# Certificate of Appropriateness

2843 W. STATE ST.      Concordia HD

PTS ID 115149 COA: porch and other repairs

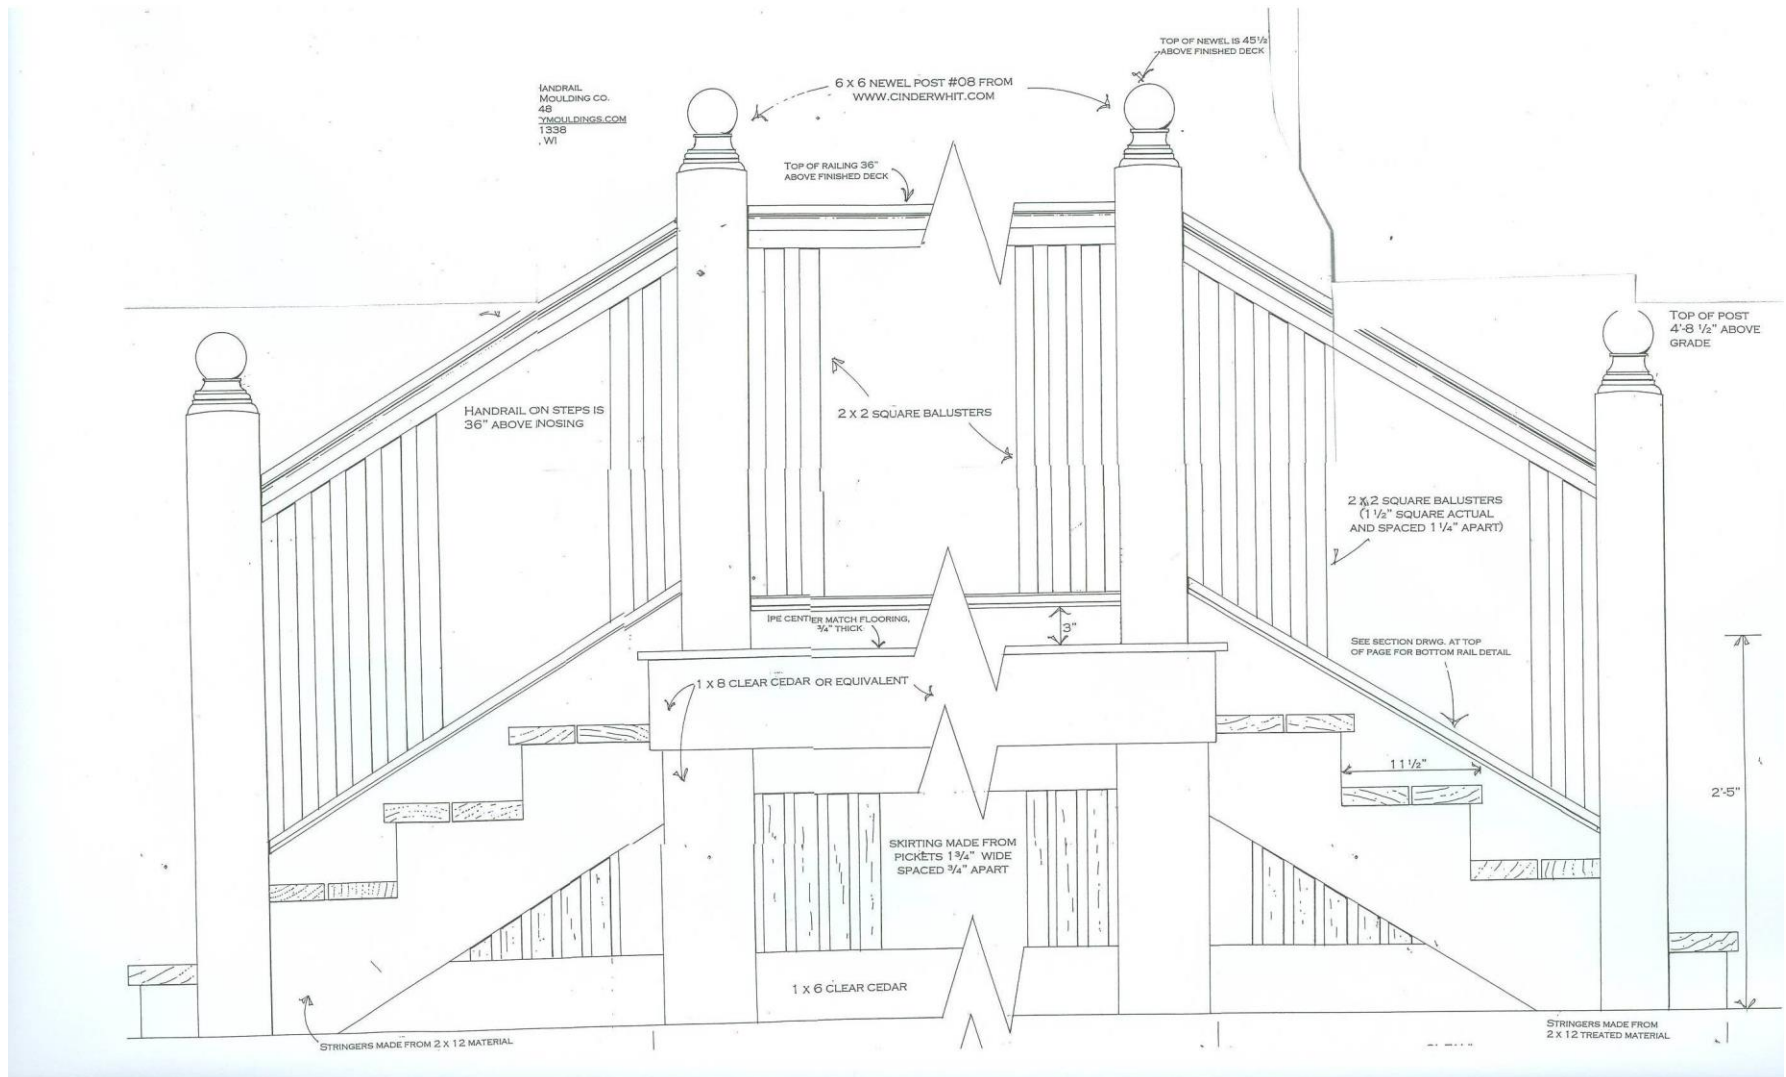
Railings will either have a pony rail above, or have an interior railing

Disregard ball finials. Use flat cap from next page for top of posts/newels.
